Site Accessibility Evaluation

Fire Station 1

**29 S Weber St
Downtown, CO 80903**

SUBJECT: Fire Station 1 Self-Evaluation

Finding: 2

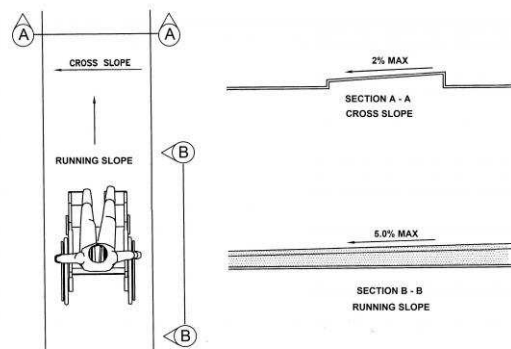
The accessible path of travel contains cross slopes greater than 2%.

The cross slope at the front of the fire station is 3 to 3.8% for about 100' of sidewalk.

If feasible, remove and replace concrete panels as needed to achieve 2% maximum cross slope.
